OHIO SCIENTIFIC

NEWSLETTER #20

September 14, 1979

## TECHNICAL INFORMATION BULLETIN

SL125/160 POWER SUPPLY

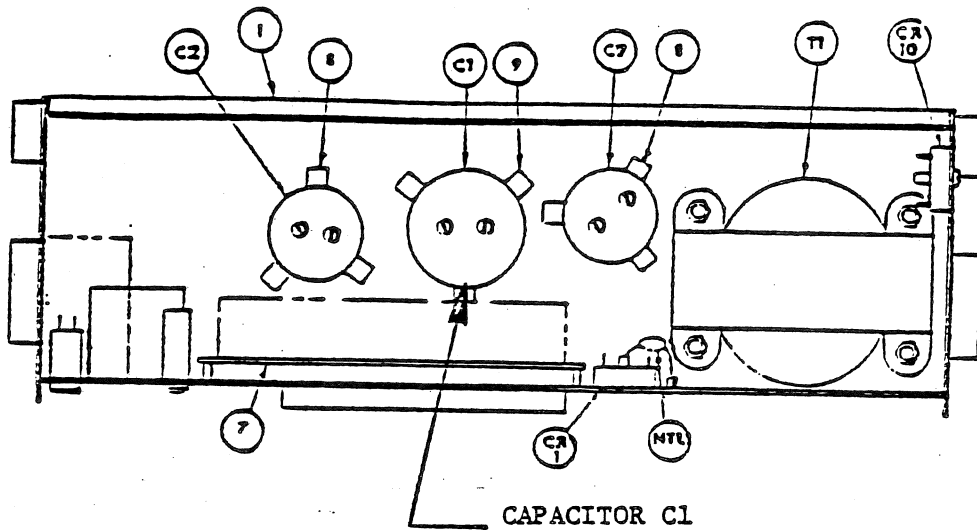
Some Slimline series Okidata Printers shipped during May, June and July, 1979, may have defective capacitors in the power supply, in the +50 VDC circuit.

MANUFACTURER	:	MEPCO
VALUE	:	31,000 ufd @ 60V
PART ID	:	31100CC313 U060
DATE CODE	:	7918

SL125/160	C1
SL250/300	C1 and C2

If this capacitor has already failed, symptoms will be one or more of the following:

- a.) Erratic or scattered print characters.
- b.) Erratic paper feed operation.
- c.) The +50 VDC voltage across the capacitor, when monitored with an oscilloscope, will appear like a sine wave ranging from 30-40 volts.

If your unit has the 7918 date code on the capacitor, Okidata will replace the cap at no cost. (Note only the capacitors indicated are in question.) You may use either of the following methods to replace the capacitor:

Should you choose option A, you will have to replace the capacitor at your site. This is a relatively simple procedure:

1. Remove power, and expose the power supply as described previously.
2. Remove the Pos (+) and Neg (-) terminal mounting screws, and remove wires
3. Loosen the capacitor mounting screw at the base of the cap.
4. Remove the capacitor and insert replacement.
5. Reassemble, and verify printer operation by executing self-test.
